Intersection ID: 48283	Main Street: MEADOWMONT_VIEW_DR	Cross Street: MEADOWMONT_VIEW_DR	Location:	SE
ADA ID: 8CF314DC282A	Ramp Type: PerpDiag	Initial Pass/Fail: Fail	Overall Compliance: No	Severity Score: 8.75

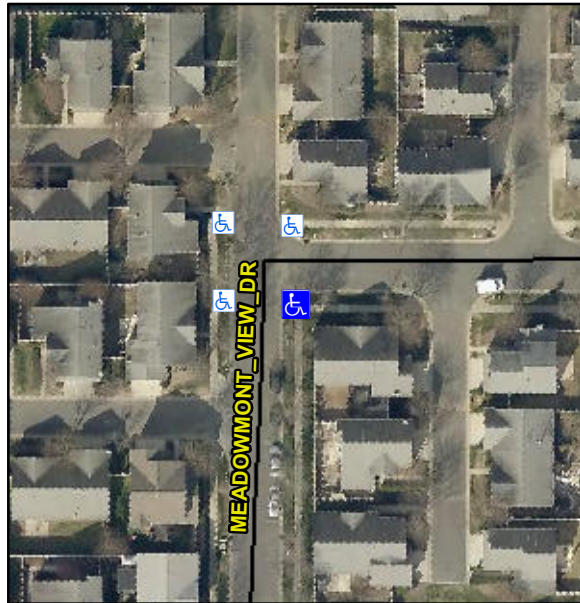
**Not Found, R304.5.1**

Compliance	Description	Data	Compliance	Description	Data
N/A	Ramp Length (in)	52.0	Yes	Ramp Slope (%)	8.3
No	Ramp Width (in)	41.0	Yes	Ramp XSlope (%)	1.0
N/A	Flare Type LT	N/A	N/A	Flare Type RT	N/A
N/A	Flare Slope LT (%)	N/A	N/A	Flare Slope RT (%)	N/A
N/A	Flare Traversable LT?	N/A	N/A	Flare Traversable RT?	N/A
N/A	Landing Length (in)	N/A	N/A	DWS Provided?	N/A
N/A	Landing Width (in)	N/A	N/A	DWS Contrast?	N/A
N/A	Landing Slope (%)	N/A	N/A	DWS Length (in)	N/A
N/A	Landing X Slope (%)	N/A	N/A	DWS Full Width?	N/A
N/A	Landing Curb? (Y/N)	N/A	N/A	DWS Offset (in)	N/A
N/A	Shared Landing?	N/A			
N/A	Gutter Ponding?	N/A	N/A	Gutter Slope (%)	N/A
N/A	Gutter Lip Ht (in)	N/A	N/A	Gutter X Slope (%)	N/A
N/A	Painted X Walk1?	No	N/A	Painted X Walk2?	No
	X Walk 1 Direction	To N		X Walk 2 Direction	To W
N/A	X Walk 1 Width (in)	N/A	N/A	X Walk 2 Width (in)	N/A
	X Walk 1 Slope (%)	0.6		X Walk 2 Slope (%)	2.1
	X Walk 1 X Slope (%)	0.4		X Walk 2 X Slope (%)	1.2

**Remove & Replace Curb Ramp With Two New Directional Ramps or Equivalent.**
